Addendum Number Two
To The Drawings and Specifications for
Juvenile Services Building
RFB Bid Number: 26-0021, Sedgwick County, Kansas

Issued: October 23, 2026

HANNEY & ASSOCIATES ARCHITECTS
1726 South Hillside, Wichita, Kansas

NOTICE TO BIDDERS
You are hereby instructed to include in your bids the following changes and/or corrections to the Drawings and Specifications for the **Construction of the New Juvenile Services Building at 881 S. Minnesota, Wichita, Kansas 67211.**

A6.9

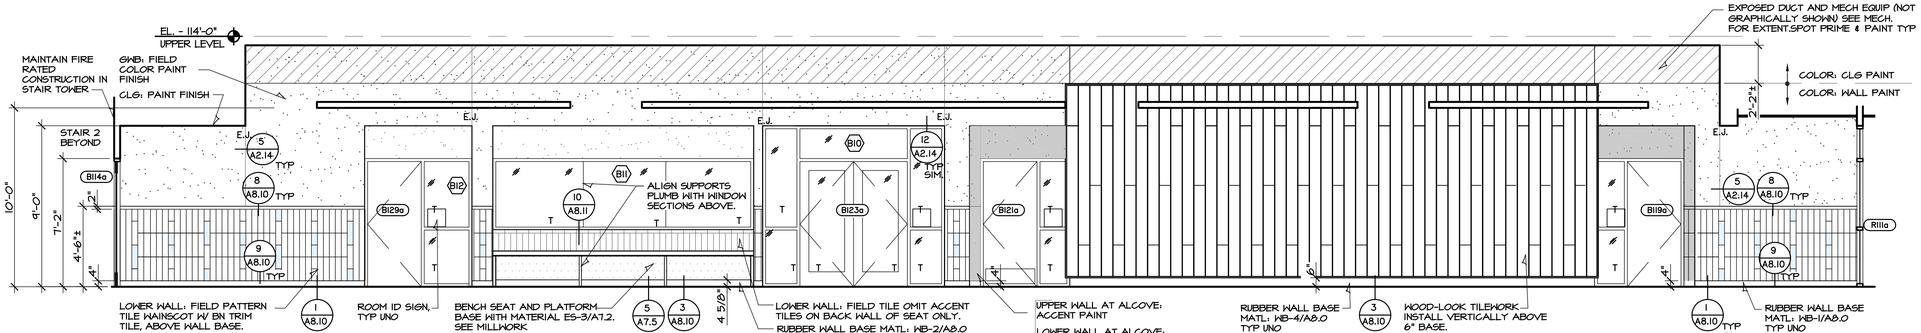
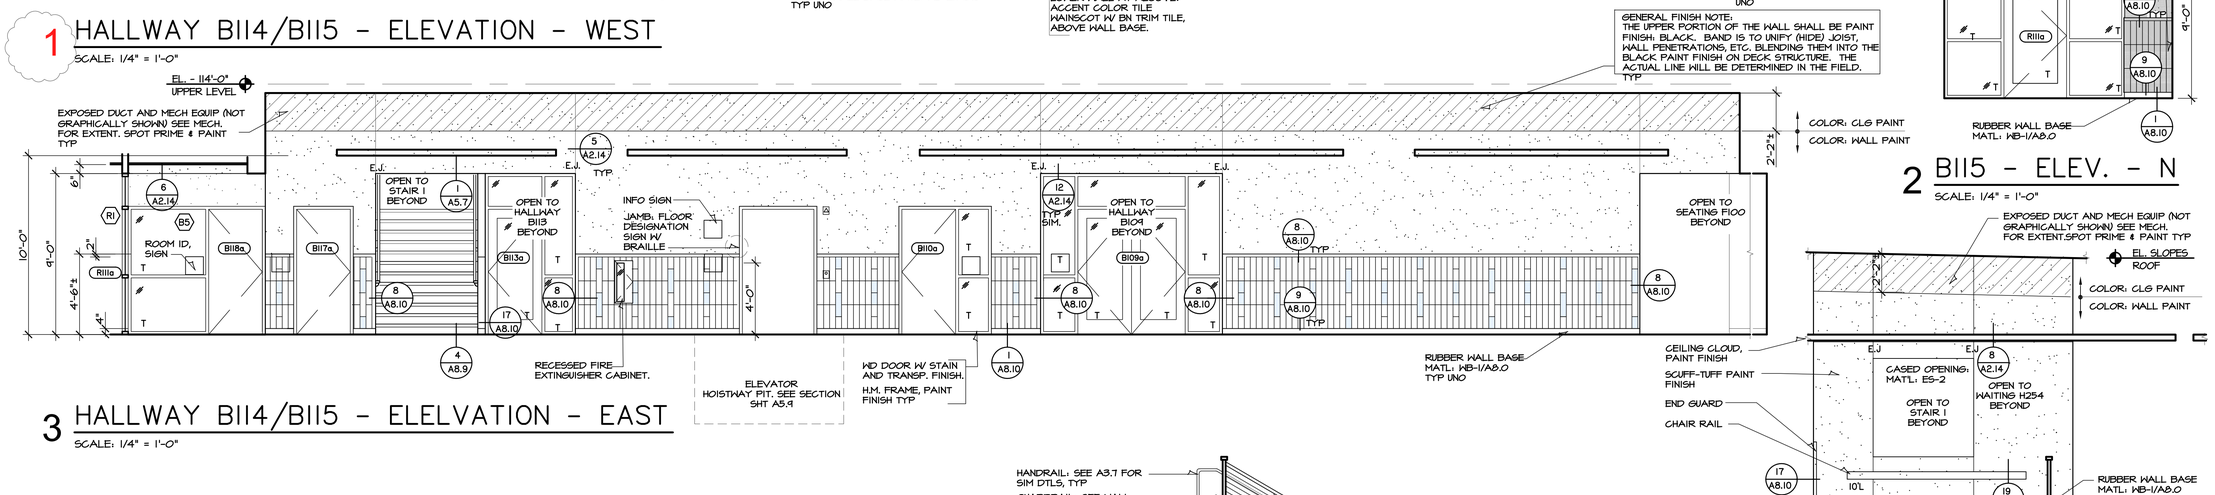
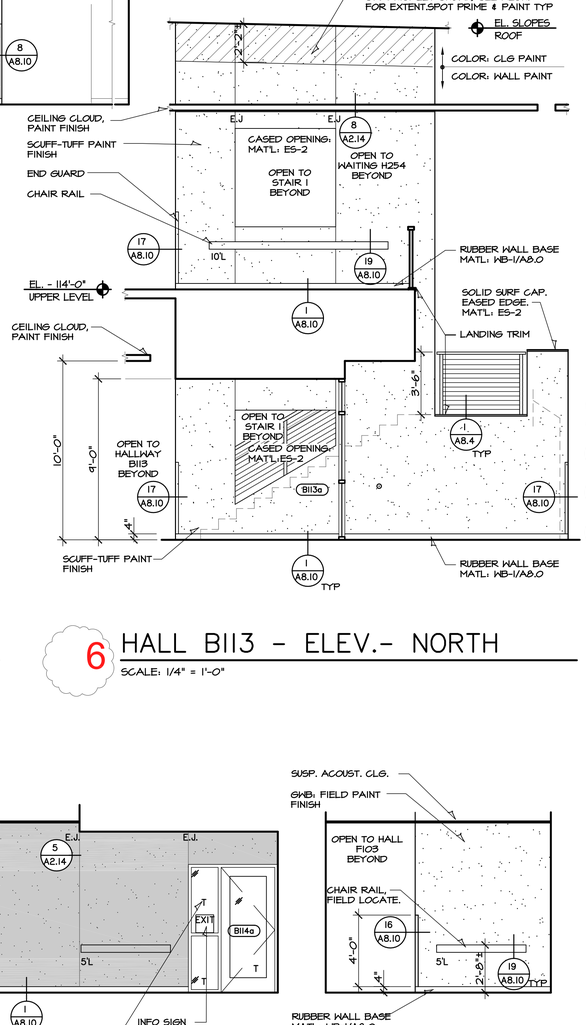
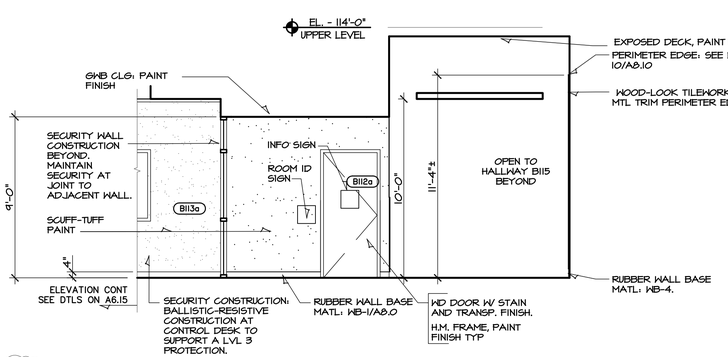
3.14 Sheet A6.9 - Interior Elevations:
Re-issued with this addendum. Revised interior elevations – 1,2,3,10, and 11

A6.12

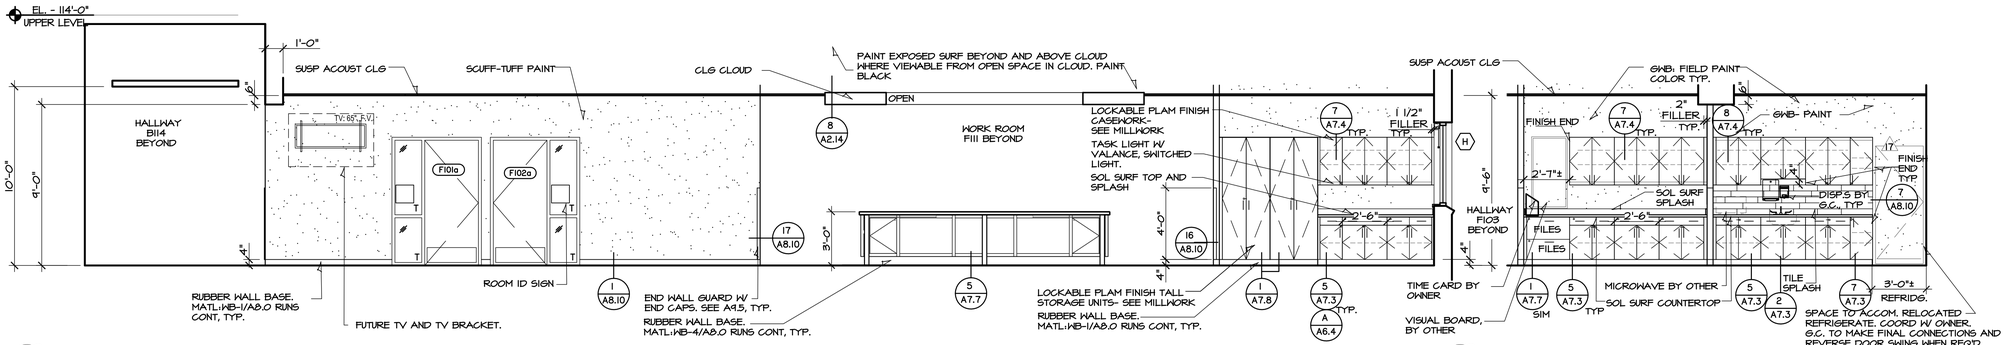
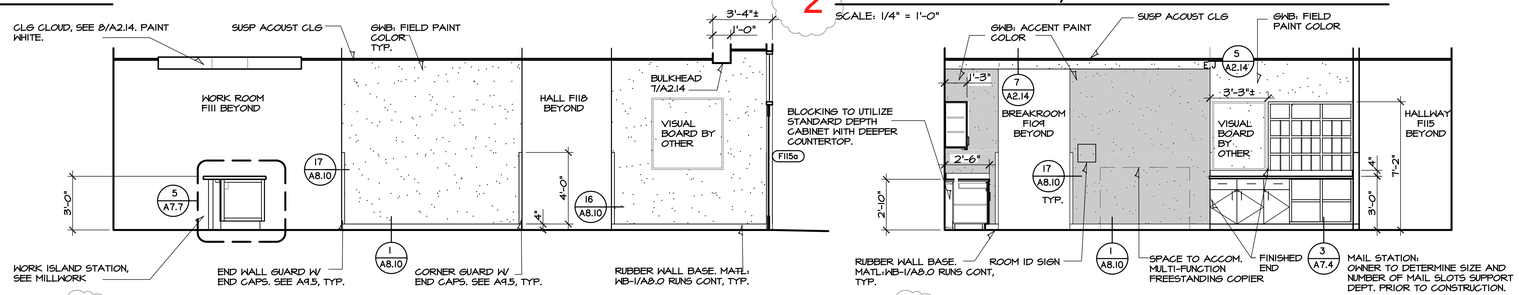
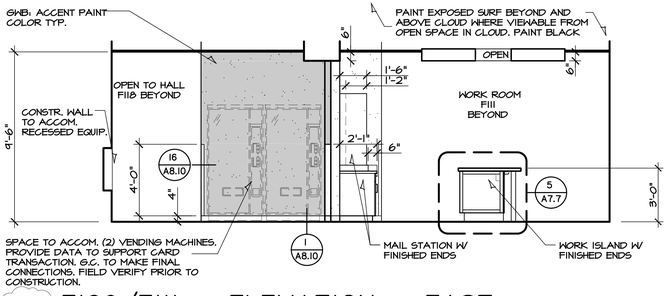
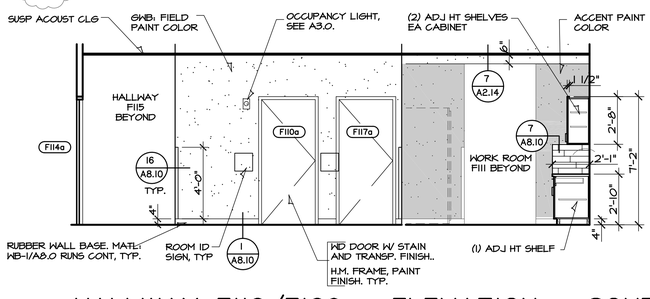
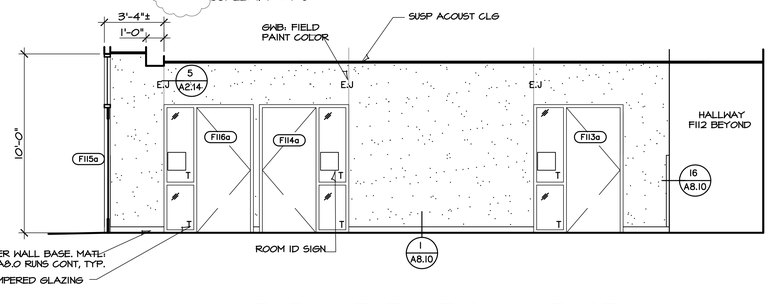
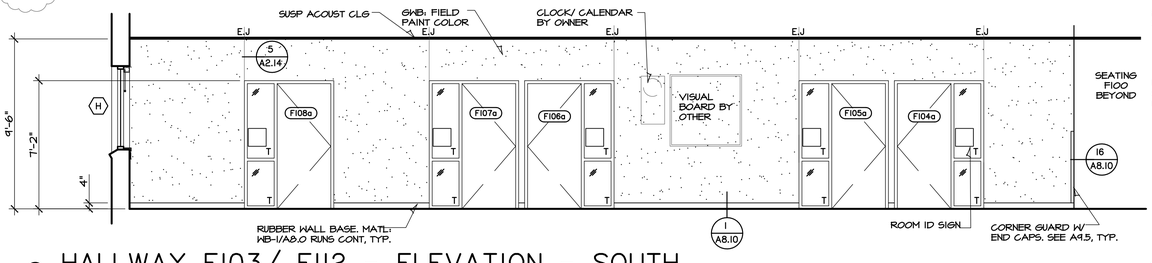
3.15 Sheet A6.12 - Interior Elevations:
Re-issued with this addendum. Revised interior elevations – 1,4,5,6, and 7

3.20 Sheet A6.12 - Interior Elevations:
Re-issued with this addendum. Revised interior elevations – 3,4,5,6,7,9, and 11

A6.13

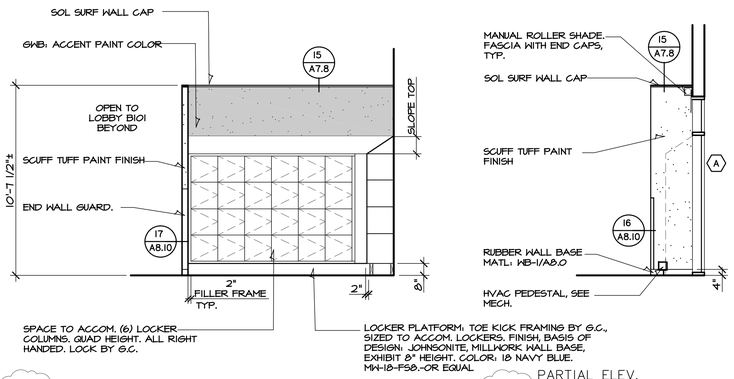
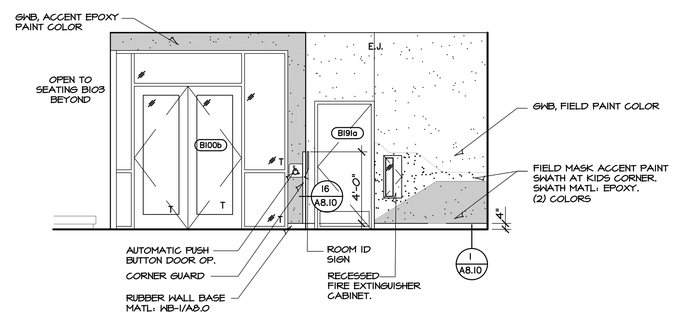
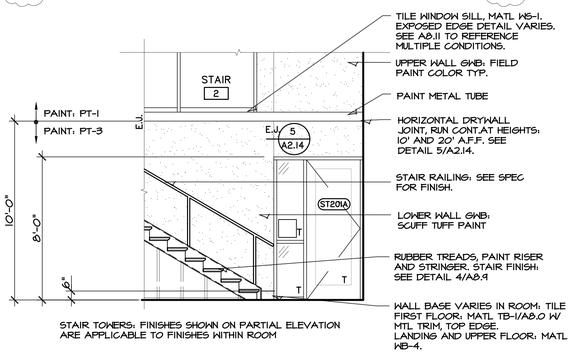
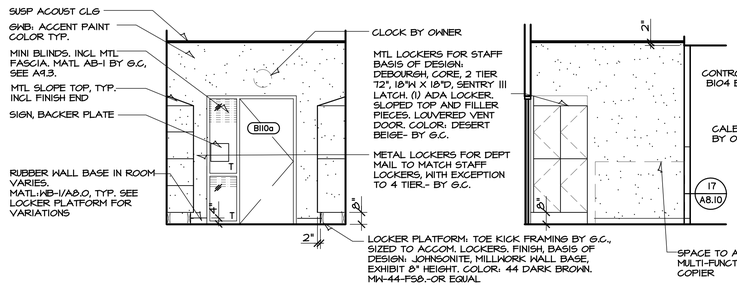
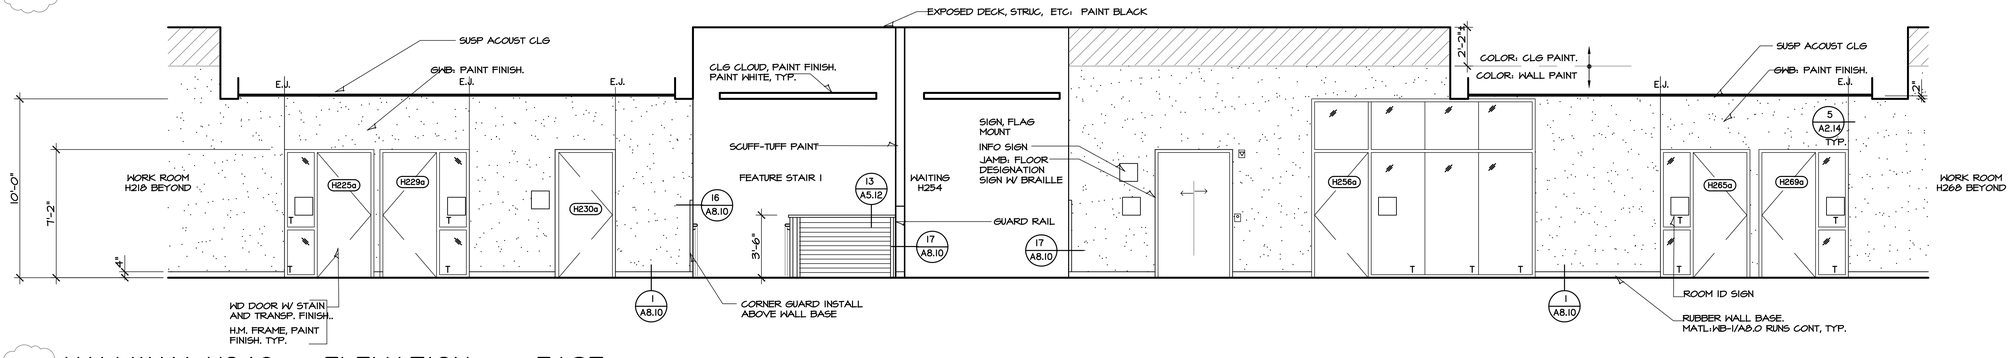
3.16 Sheet A6.13 - Interior Elevations:
Re-issued with this addendum. Revised interior elevations – 1,2,4,5, and 6

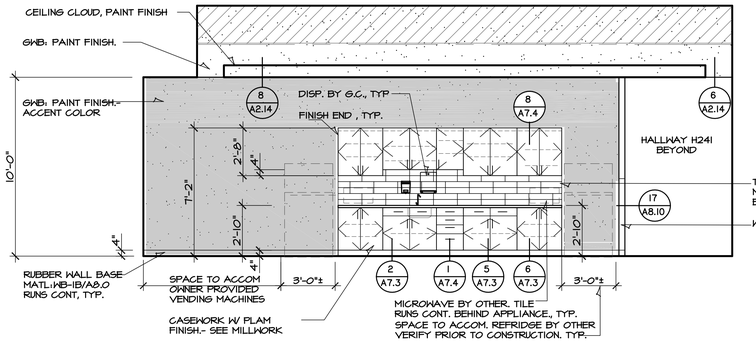
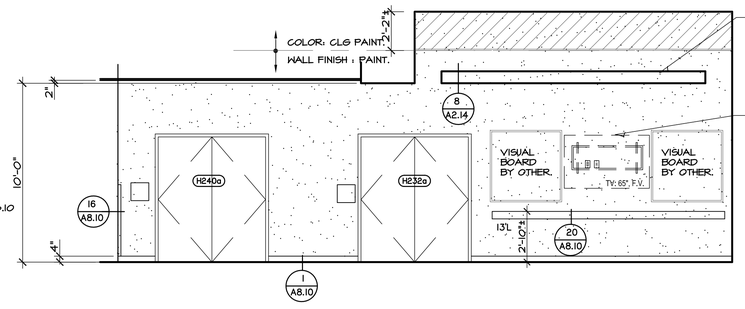
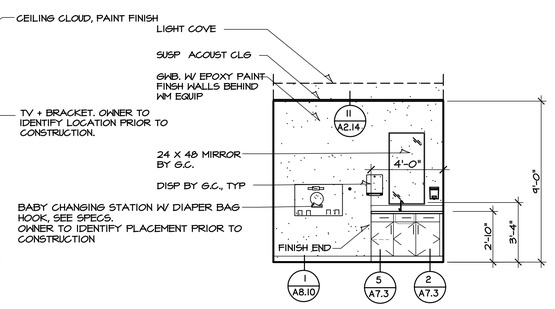
3.19 Sheet A6.18 - Interior Elevations:
Re-issued with this addendum. Revised interior elevations – 4,5,6,7,8,9, and 11

SHEET
M6.2

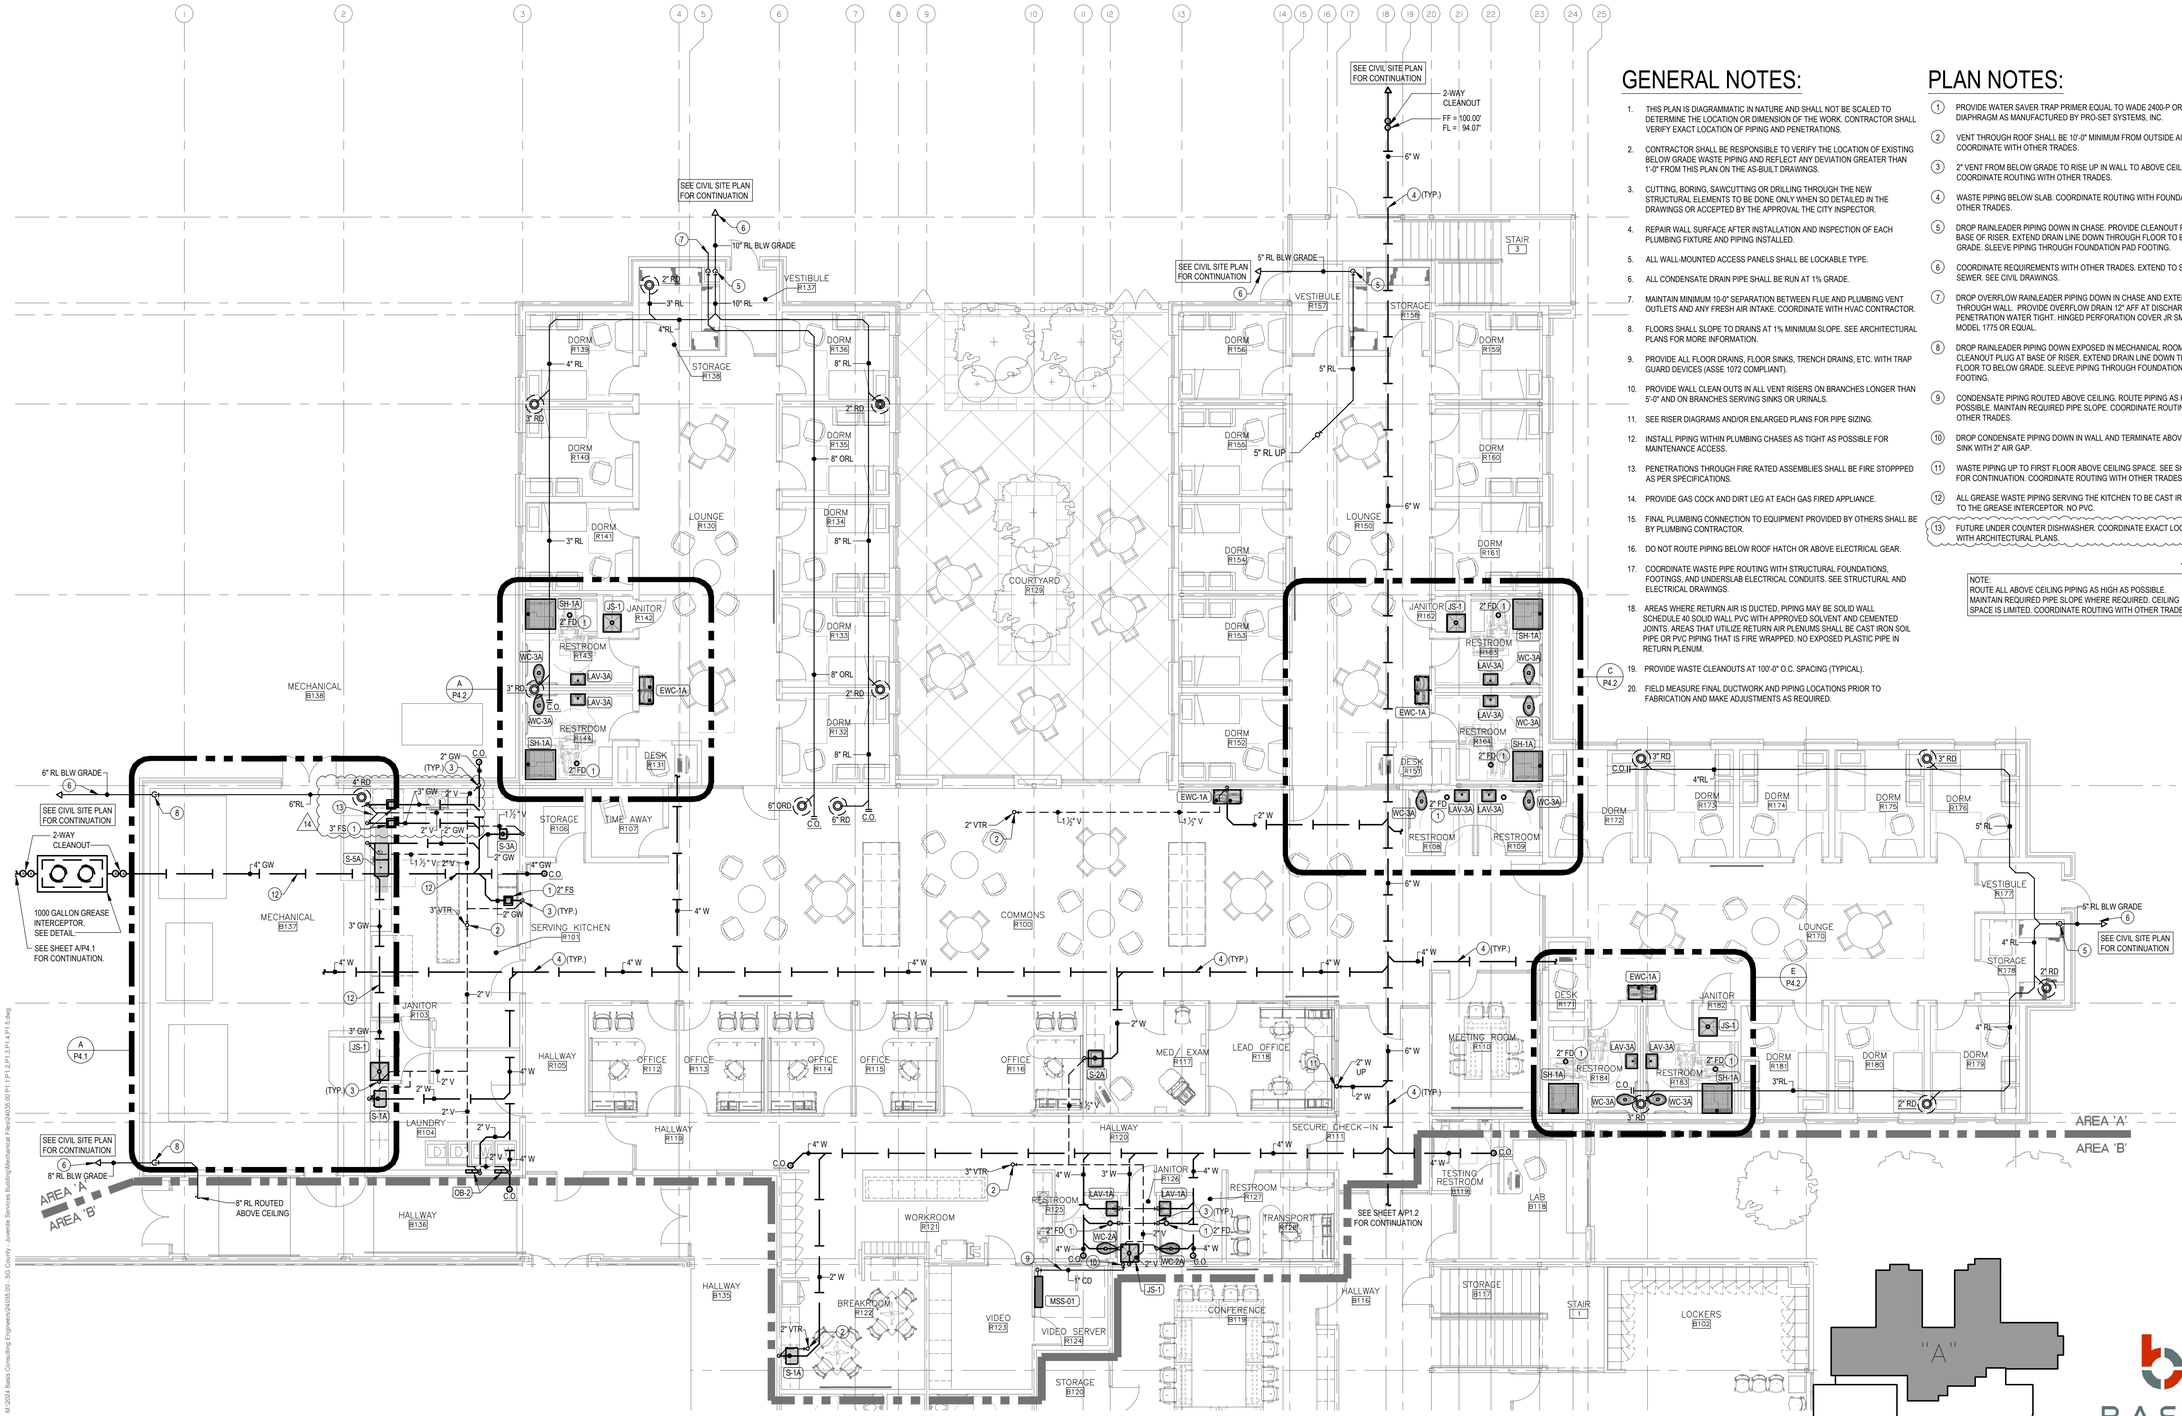
3.21 Sheet M6.2: See clouded changes.
Updated Pump schedule:
Remarks #3: Delete “Fully grouted base” for primary chiller pumps
